**AOS SPACE DATA
LINK PROTOCOL**

CCSDS 732.0-P-4.2

PINK SHEETS
September 2024

Figure 4-2: Transfer Frame Primary Header

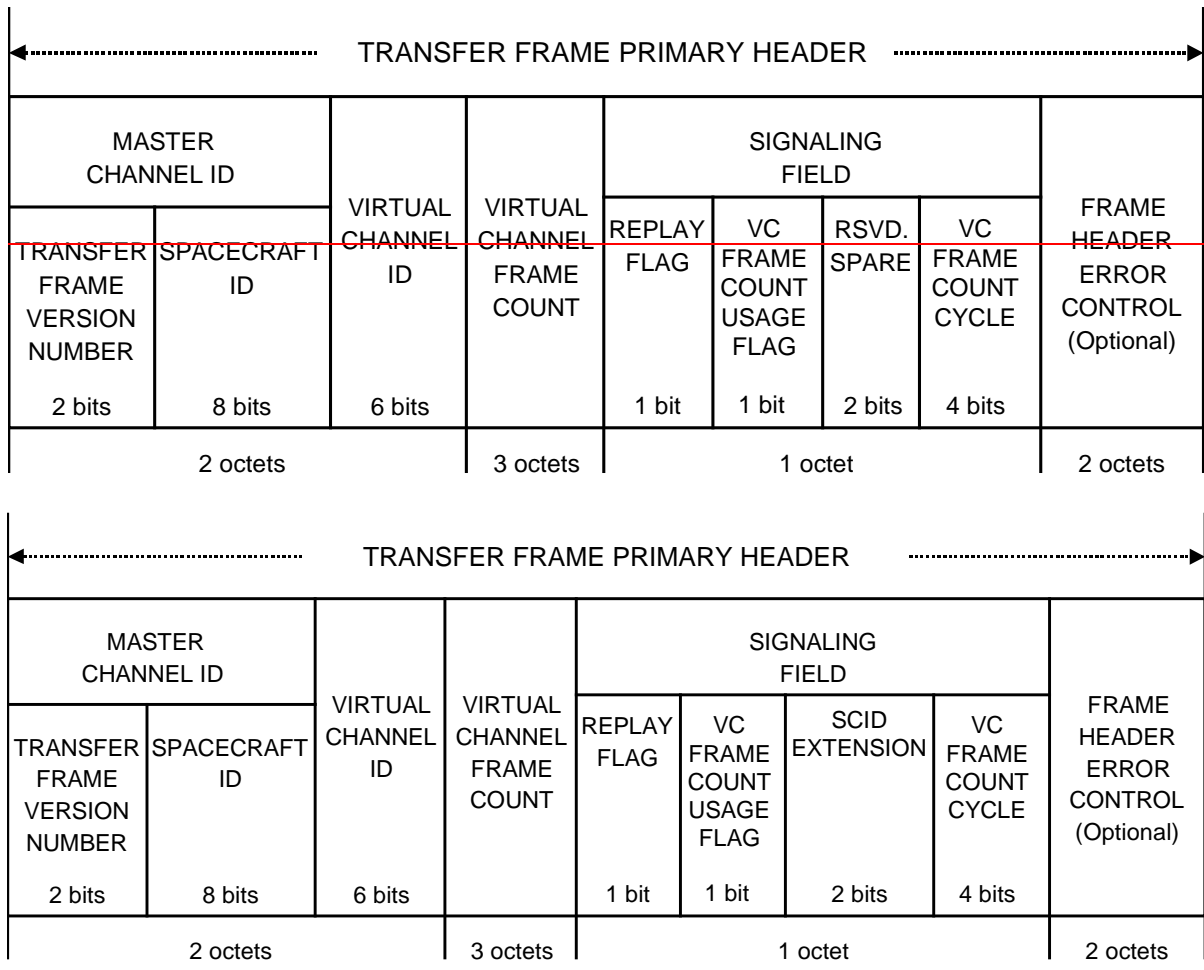
~~Bits 2–9 of the Transfer Frame Primary Header shall contain the Spacecraft Identifier (SCID).~~

4.1.2.2.3.1 The length of the Spacecraft Identifier (SCID) depends upon the value of the 2-bit SCID Extension field (defined in 4.1.2.5.4). The SCID can be either 8 or 10 bits in length.

4.1.2.2.3.2 If the SCID Extension field is set to ‘00’ then bits 2-9 of the Transfer Frame Primary Header contain the Spacecraft Identifier, defining the 8-bit SCID.

4.1.2.2.3.3 If the SCID Extension field is not set to ‘00’ then these two bits are to be interpreted as two additional high-order bits added at the beginning (i.e., the most left justified when drawing a figure) of the 8-bit SCID, defining the 10-bit SCID.

- a) Replay Flag (1 bit, mandatory);
- b) Virtual Channel (VC) Frame Count Cycle Use Flag (1 bit, mandatory);
- c) ~~Reserved Spares~~ SCID Extension (2 bits, mandatory);
- d) Virtual Channel Frame Count Cycle (4 bits, mandatory).

4.1.2.5.4 ~~Reserved Spare~~ SCID Extension

4.1.2.5.4.1 Bits 42-43 of the Transfer Frame Primary Header shall contain the ~~reserved spare~~ SCID Extension.

NOTE – The SCID Extension provides a mechanism to extend the SCID from 8 bits to 10 bits, thereby increasing the number of spacecraft addressable by this protocol.

4.1.2.5.4.2 ~~This 2-bit field is reserved for future definition by CCSDS and shall be set to '00'. The interpretation of this field is defined in 4.1.2.2.3.~~
